State of Alaska  
Department of Fish and Game  
Sportfish Division

Nomination Form  
Fish Distribution Database

Nomination # <u>07-238</u>	ADF&G Fisheries Scientist	Date
Revision Year: <u>2006</u>		
Revision to: Atlas <input type="checkbox"/> Catalog <input type="checkbox"/>	ADNR OHMP Operations Mgr.	Date <u>10/29/07</u>
Both <input type="checkbox"/>	<i>[Signature]</i>	Date
Revision Code: <u>F-2</u>	FDD Project Biologist	Date
	Cartographer	Date

SUBJECT: Transmittal Letter for Nomination to Delete a Portion of Ship Creek from the Atlas and Catalog of Waters Important for Spawning, Rearing or Migration of Anadromous Fishes

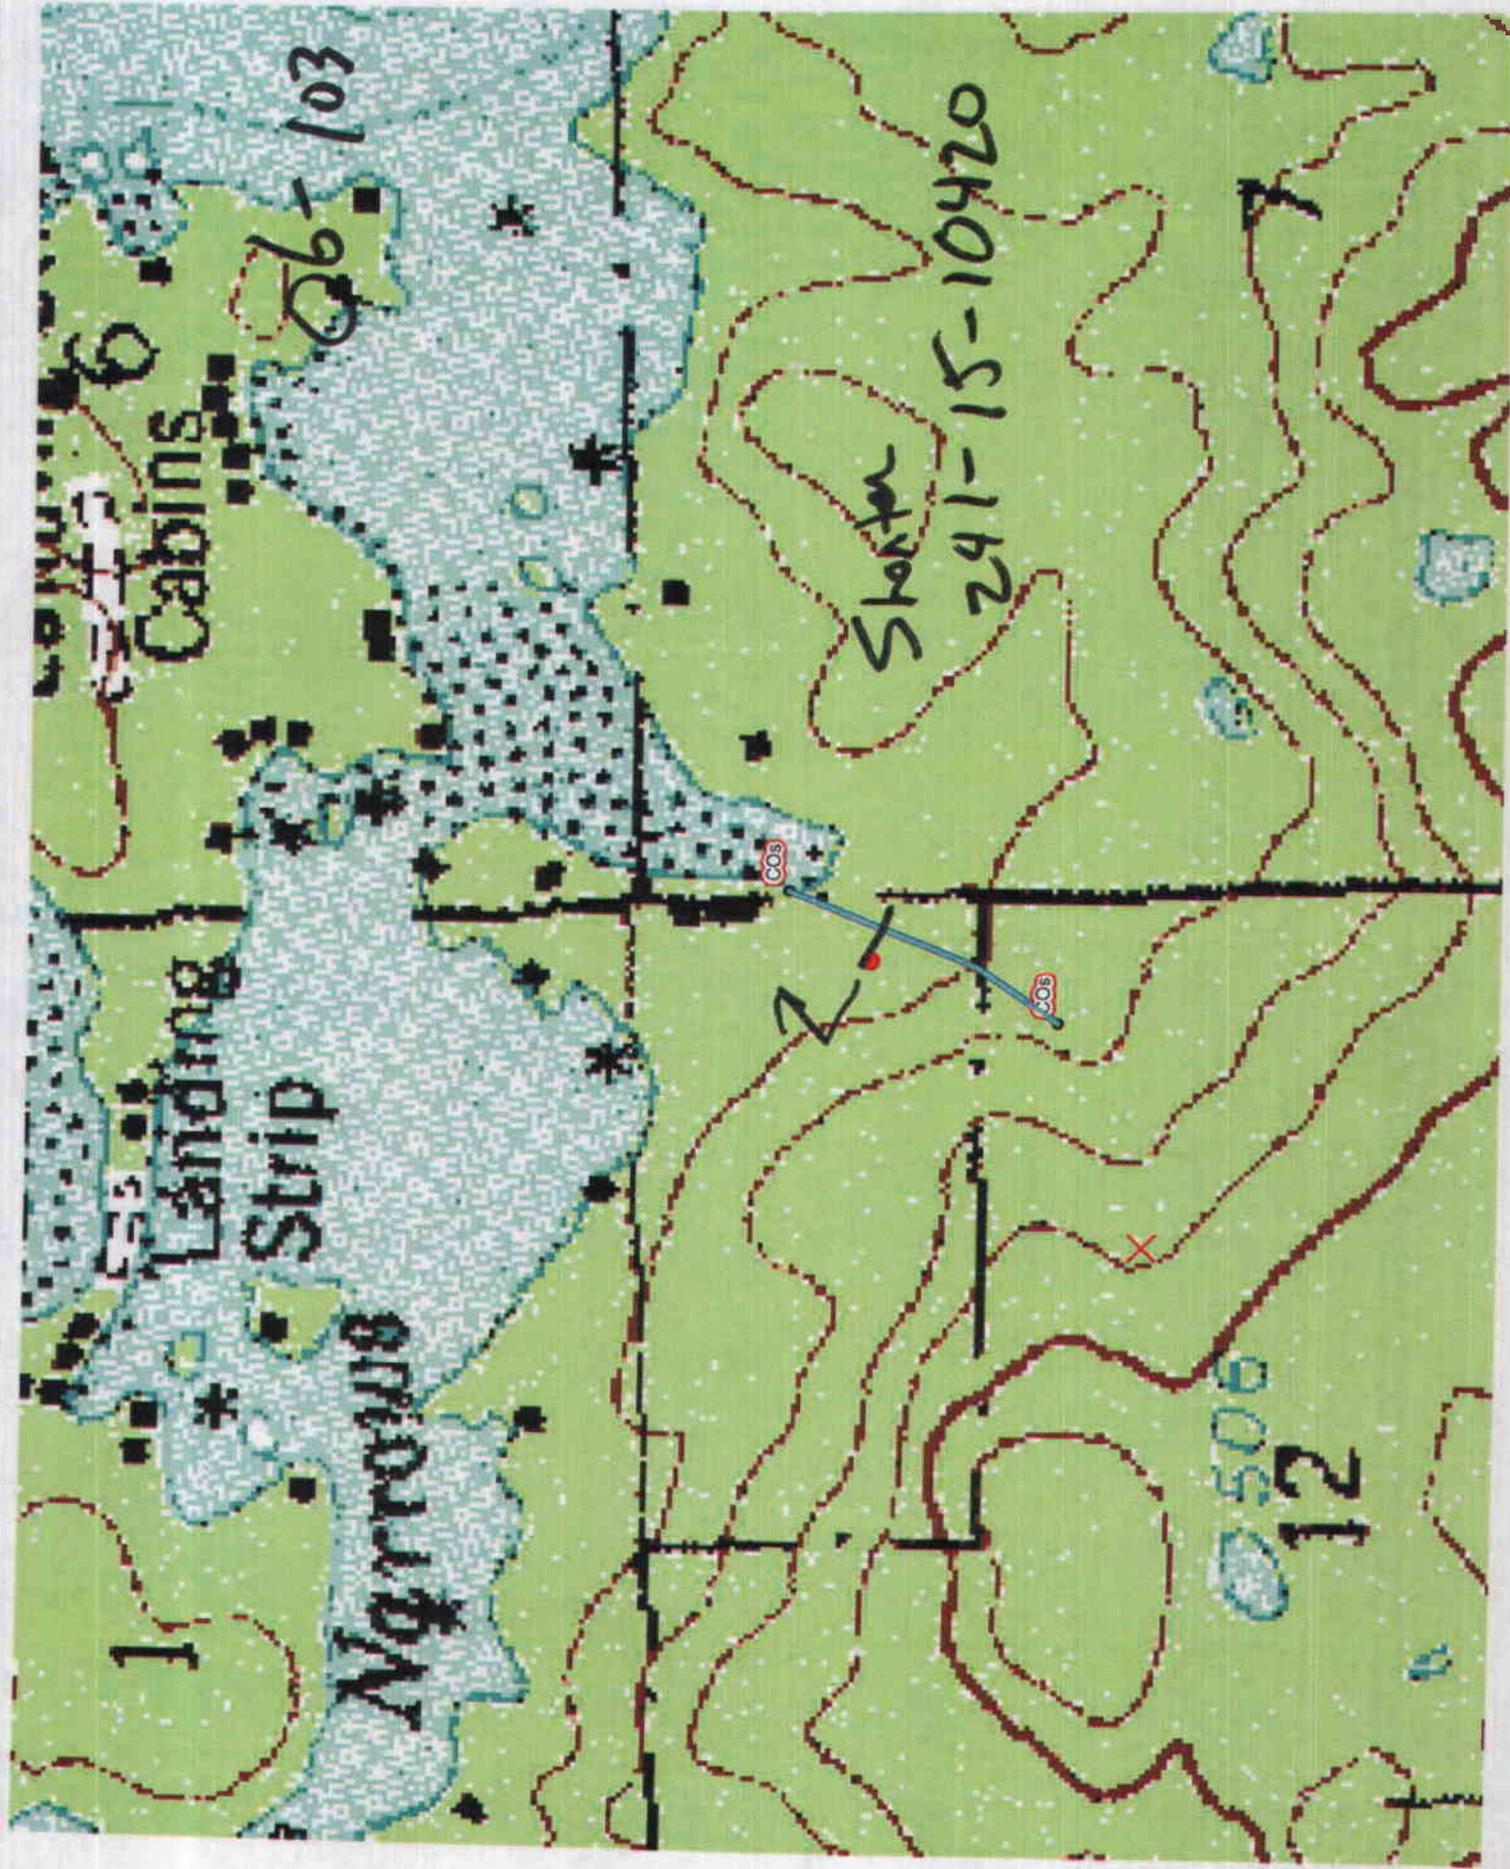
On August 29, 2006 a local resident and I walked the unnamed Halibut Cove stream (now cataloged as Stream No. 241-15-10420) from the mouth, upstream to a 15 to 20 foot natural waterfall (59°35.351' N, 151°13.983' W). There were no pools in between the 15 to 20 foot drop, nor enough water depth to allow fish passage. The stream consists of a series of small pools and cascading waterfalls with large rock. I didn't observe any fish or spawning habitat between the waterfall and the mouth but the waterfall was the first definitive fish pass obstacle.

the attached pdf displays the location (red dot) of the waterfall based on the lat/long provided on the nomination to FDD you submitted. The red dot marks the spot. Since the red dot is off the stream arc a bit I would like know if red dot was shifted to arc (blue line) would that represent location to shorten arc?
